WATTS BAR NUCLEAR PLANT

EVALUATION OF BLACK AND VEATCH INDEPENDENT REVIEW

MARCH 16, 1984

WATTS BAR NUCLEAR PLANT
INDEPENDENT REVIEW
FINAL SUMMARY REPORT

FIGURE B1

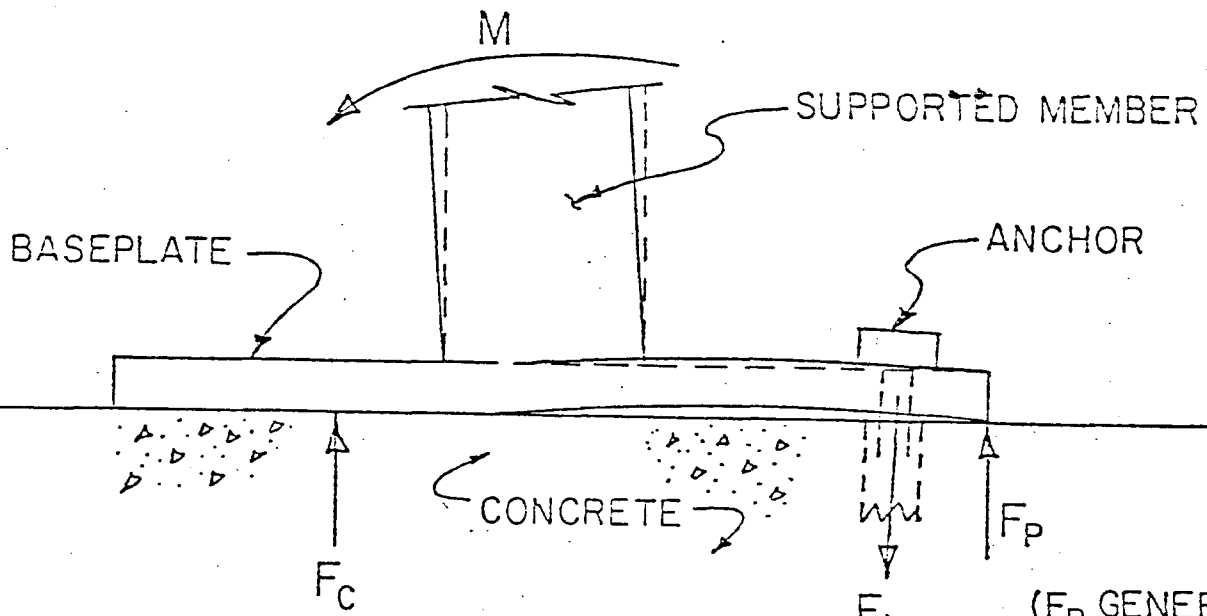
The Black and Veatch (B&V) final evaluation indicates that the finding would remain open for two reasons relating to OIE Bulletin 79-02:

1. No information was supplied to B&V which indicated NRC acceptance of a factor of safety of less than 5.0 for expansion anchors.
2. No data or test results were supplied to B&V which indicated that prying action was considered in TVA's baseplate evaluation for OIE Bulletin 79-02.

The second concern involves prying action. Baseplates for pipe supports and similar attachments which are loaded with tensile loads or bending moments may develop prying forces. The mechanism which results in prying for a typical pipe support is illustrated in Figure B1. The magnitude of the prying force depends primarily on the following variables; the stiffness of the plate, the stiffness of the anchor, and the preload in the anchor. If prying action exists, the prying force will place additional tensile load in the anchor.

As part of TVA's evaluation for NRC-OIE Bulletin 79-02, a sample of 40 expansion-anchored baseplates was analyzed using flexible plate analysis. The plates were originally analyzed using rigid plate analysis. The flexible plate analyses showed that no prying force exists for these plates because the corners of the plates adjacent to the tensile anchors lifted off the concrete (see Figure B2). This indicates that expansion anchor deformations resulted in sufficient plate movement to relieve prying forces.

The flexible plate analysis was performed using a finite element program (BASEPLATE II) which considers the three primary variables mentioned above. The anchor stiffnesses used were obtained from load deflection curves from anchor tests. A preload was not used. The self-drilling anchors are not capable of maintaining a significant preload because of their short length and low steel stress. If the plates in the sample had remained in contact with the concrete, the finite element analysis would have verified the existence of a prying force and would have included its effect in the anchor load.

In summary, TVA evaluated prying action for the 79-02 Bulletin work but this evaluation showed that prying forces do not develop for baseplates with self-drilling expansion anchors. This determination has been validated by testing.
